Interactive comment on “Distributed model of hydrological and sediment transport processes in large river basins in Southeast Asia” by S. Zuliziana et al.

Our response to the referee’s comments are as follows;

Figure 1. The concept of hillslope based DHM where hydrological processes and river routine take place

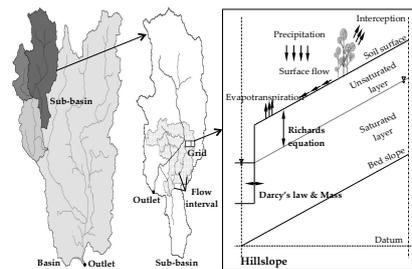
Q3. The hydrological hillslope model is based on the calculation of runoff generation in hillslope units. It remains unclear how large these units are and how the discharge is distributed across the apparently smaller grid cells of the sediment transport module.

A3. In hydrological hillslope model, the runoff was generate in hillslope units. The hillslope unit is viewed as a rectangular inclined plane with a defined length and unit width. The inclination angle givens by the corresponding surface slope. Figure 1 show the concept of hillslope based on distributed hydrological model used in this study.
